M	VP Varia	ance Requ	uest	Form	Varia	ance Request	
	etaia			oto An	proval De	aucotod	No.: by Contractor:	A-22
	ntain		9/19/2018 9/21/2018					
	PIPELINE uc		Da				spector to LEI: ved by FERC:	3/2 1/2010
			FERC /	Approv	al Refere			
Deguasted By	,				Spread	٨	Variance	WS
Requested By:	E	Brent Ladd			Spread:	A Varian	Type: ce Sequence	VV 5
Request Prepared By *:		gan Neylon					Number:	022

Mountain Valley Pipeline Project Variance A-22 September 5, 2018

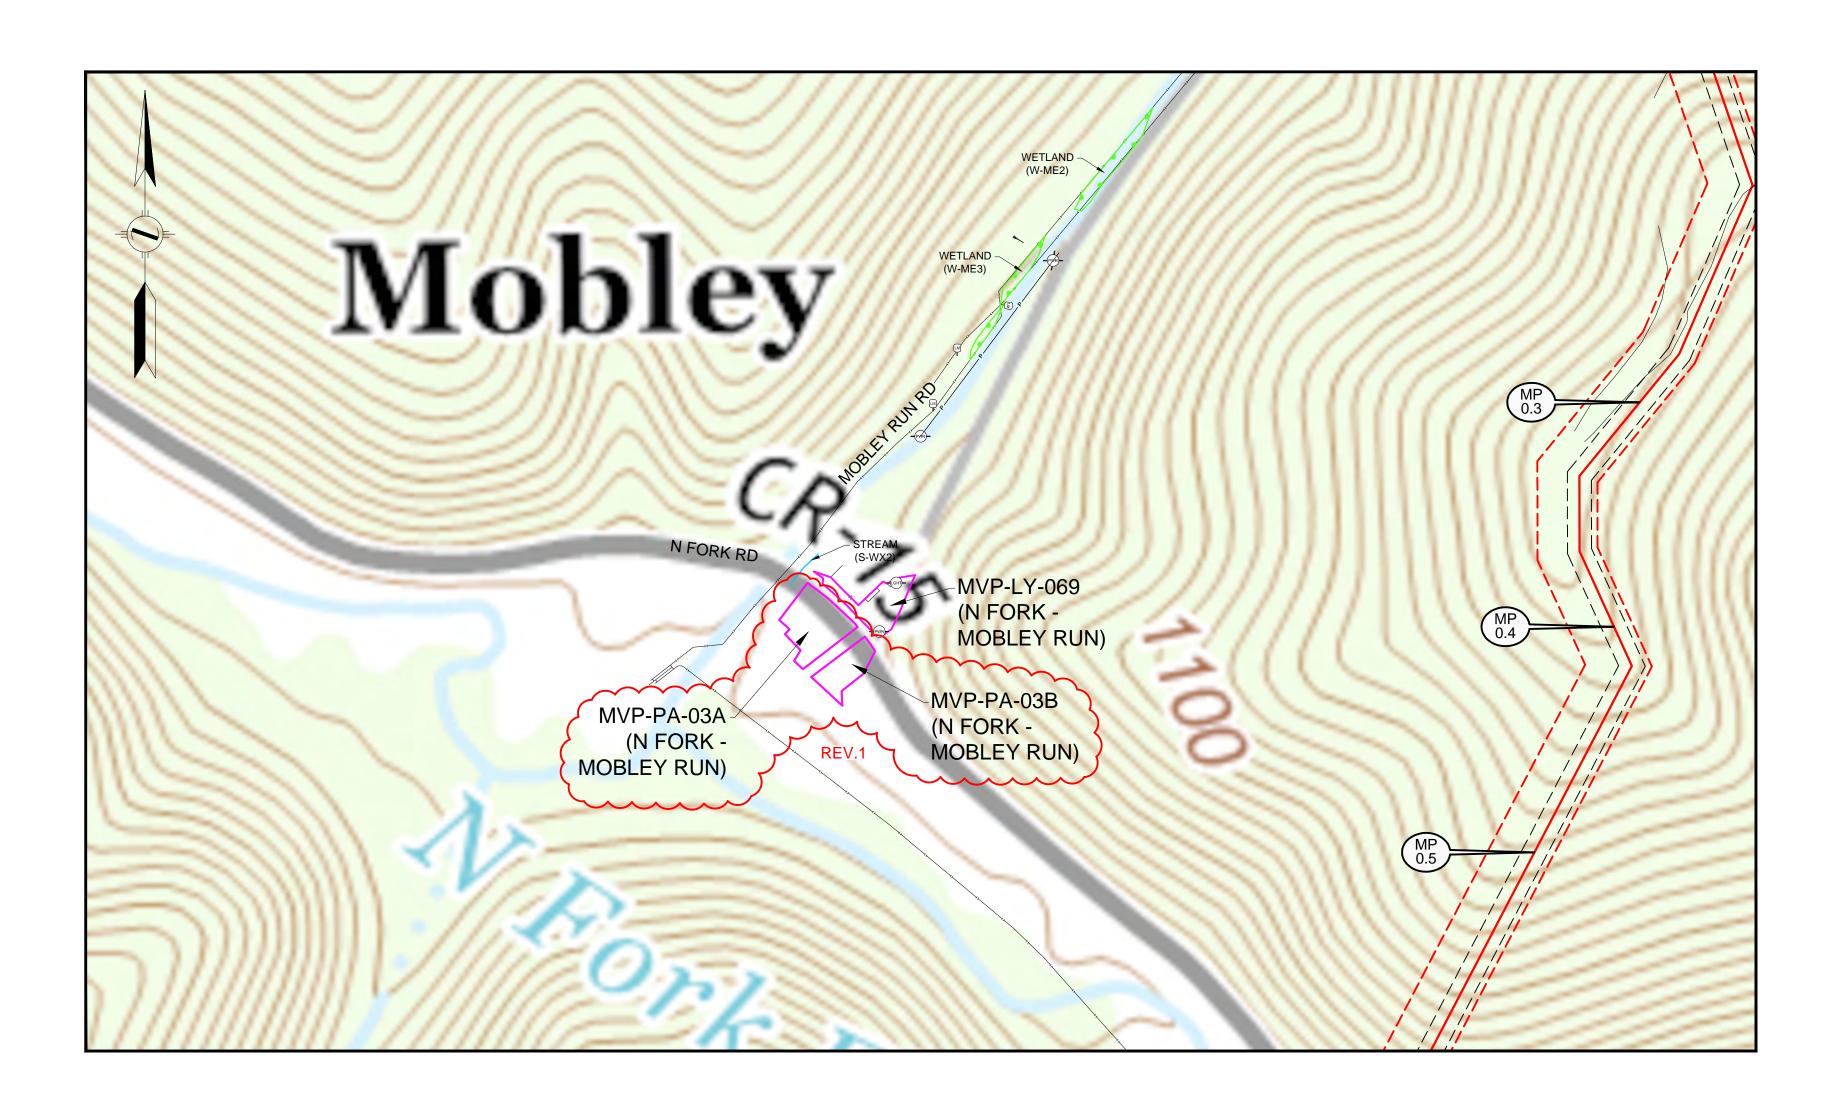
ine List				Other: Desc	cribe:		
Detailed Description of Va	riance:	Attachmen	ıts? ☑ Ye	es 🗆] No	Photo	os?	Yes 🔽 No
This variance adds MVP-PA-0	03A and MVP-PA-	003B for ac	Iditional off-ROV	V parki	ing. No gr	ading will	be necessary in	these parking areas,
gravel will be added as necess species were identified during s								
variance has a net increase of								
List Attachments:	Attachment 1-Ali	~						
List Attachments:	Attachment 1-Ali Endangered Spec Report; Attachm	cies Report;	Attachment 3- V	Vaterbo	odies and	Wetlands		
List Attachments:	Endangered Spec Report; Attachm DO NOT RELEAS	cies Report; ent 4- Cultur SE) ; Attachr	Attachment 3- V ral and Historic I ment 5- Landow	Vaterbo Resour ner Exf	odies and ces (CUI/, hibits (CUI	Wetlands /PRIV I//PRIV		
List Attachments:	Endangered Spec Report; Attachm	cies Report; ent 4- Cultur SE) ; Attachr	Attachment 3- V ral and Historic I ment 5- Landow	Vaterbo Resour ner Exf	odies and ces (CUI/, hibits (CUI	Wetlands /PRIV I//PRIV

LEGEND		REFERENCE DRAWINGS				REVISIONS		APPROVED		APPR	
ANCILLARY SITE		DRAWING NUMBER	TITLE	REV. B	7 DATE F 06-01-18	DESCRIPTION ISSUED FOR VARIANCE		FOREV. B	OR FERC	FOR B	<u> </u>
TEMPORARY ACCESS ROAD PROPOSED H600 PIPELINE	WATER LINE					ISSUED FOR VARIANCE - ADDED MVP-PA-03A & MVP-PA-03B					_
PROPOSED PERMANENT EASEMENT TEMPORARY WORK SPACE							ENGINEERING				
ADDITIONAL TEMPORARY WORK SPACE	BUILDING WETLAND						220 Hoover Boulevard, Suite 2				_
	STREAM						220 Houver Bollevald, Suite 2 20555 Evergreen Rd. Suite. 430 Holland, Michigan 49423-3766 Southfield, Michigan 48076 T 616-392-5938 F 616-392-2116 T 248-827-7322 F 248-827-7549				_
	PROJECTION: UTM ZONE 17										
 Image: Image: Im	HORIZONTAL DATUM: NAD 83 US SURVEY FEET VERTICAL DATUM: NAVD88						www.hollandengineering.com				_
											_
